# NORTH COAST RAIL TRAIL FINAL ENVIRONMENTAL IMPACT REPORT

## ADDENDUM

March 2020

This document is an addendum to the North Coast Rail Trail Final Environmental Impact Report (EIR) (SCH #2017092034, hereafter referred to as Final EIR).

*Chapter 2, Project Description, Section 2.4, Project Characteristics, under the heading Trail, Figures 2-3a, 2-3b and 2-3c, North Coast Rail Trail Representative Cross-Section of Proposed Project*

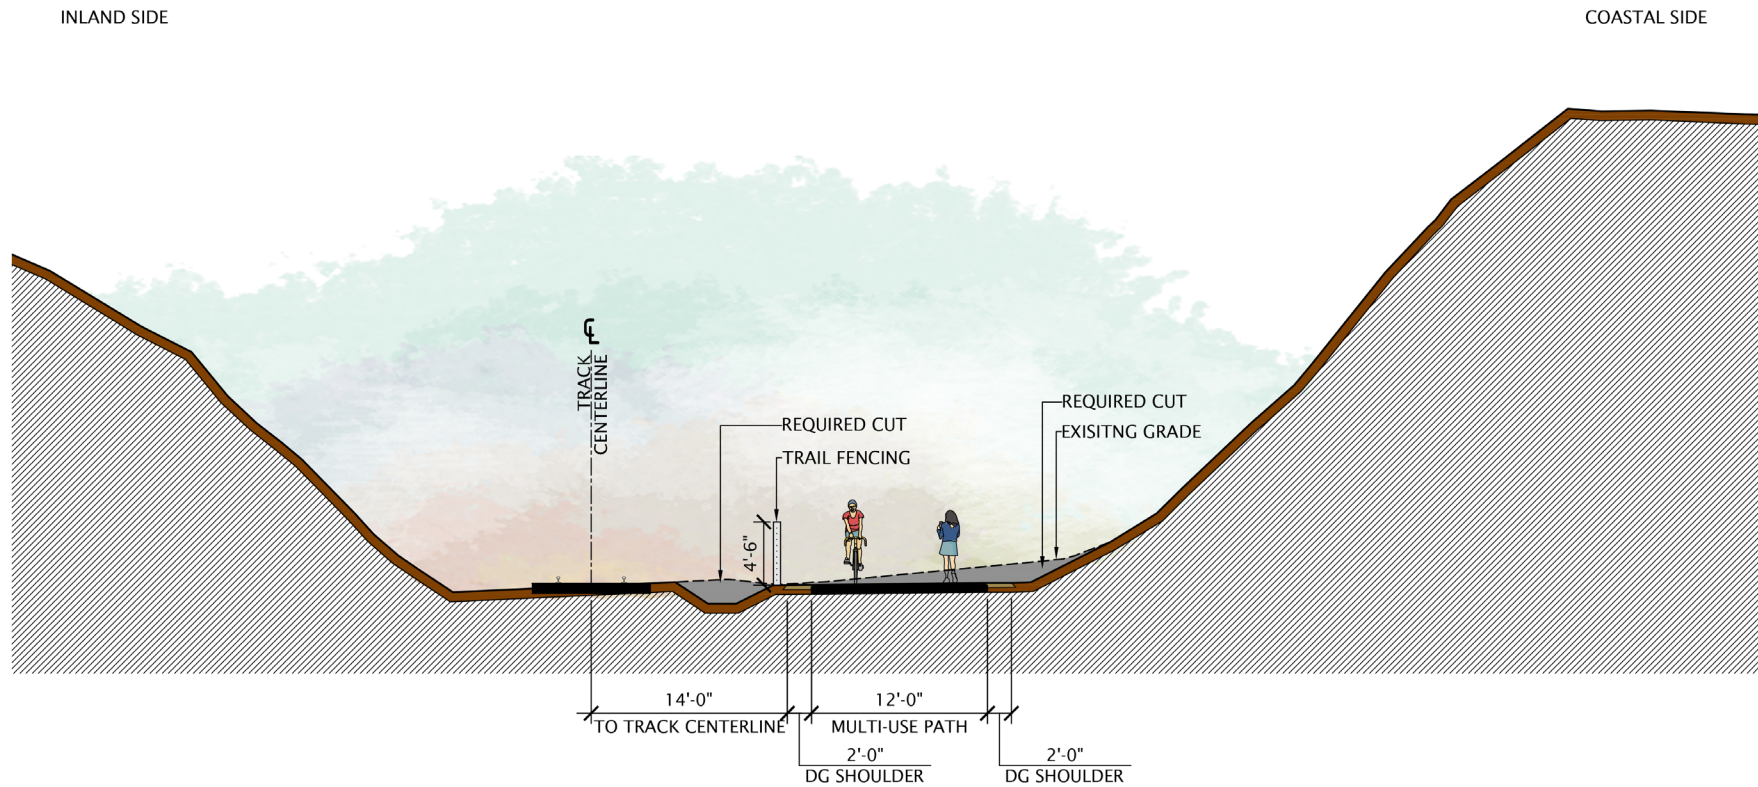
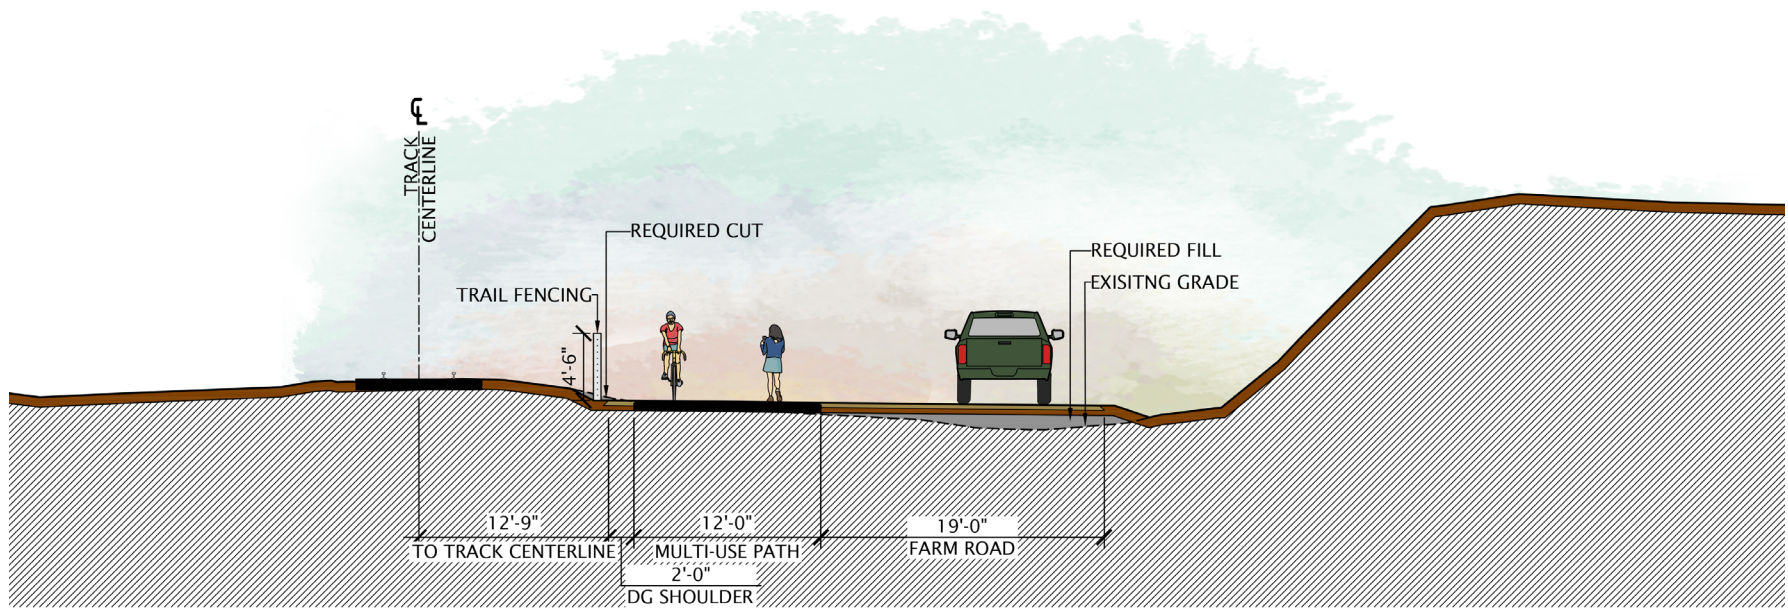
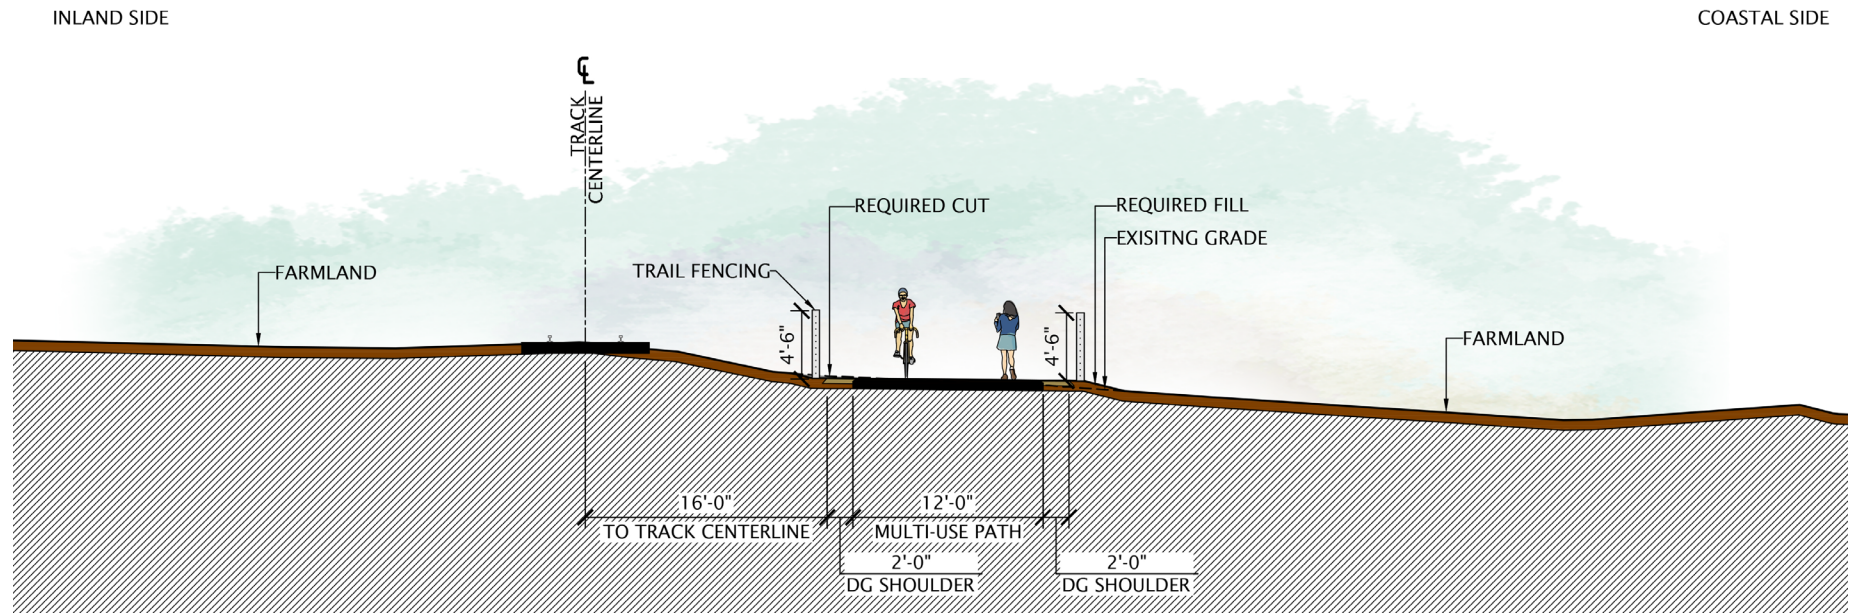
The typical trail cross-section would be 16 ~~20~~ feet wide and would consist of:

- 12-foot-wide paved path with striping to separate northbound and southbound
- 2 ~~6~~-foot-wide unpaved shoulder on the coastal side of the paved path
- 2-foot-wide unpaved shoulder on the inland side of the paved path
- Safety fencing between the trail and tracks

Representative cross-sections of the Proposed Project are shown in **Figure 2-3a** through **Figure 2-3c**. The 12-foot-wide paved path would be consistent throughout the length of the alignment, with the exception of ~~but the width of the 6-foot-wide unpaved shoulder on the coastal side could be reduced to 4 or 2 feet to minimize slope cuts and maintain the required distance between the paved trail and railroad tracks. The locations of reduced width total approximately 4,400 linear feet. For both design options at Shark Fin Cove, the width would be 16 feet total, with 12-foot-wide paved path and 2-foot-wide unpaved shoulders on each side; and the total length is approximately 3,900 linear feet. The trail connection to Wilder Ranch~~ which would be a 10-foot-wide paved path.
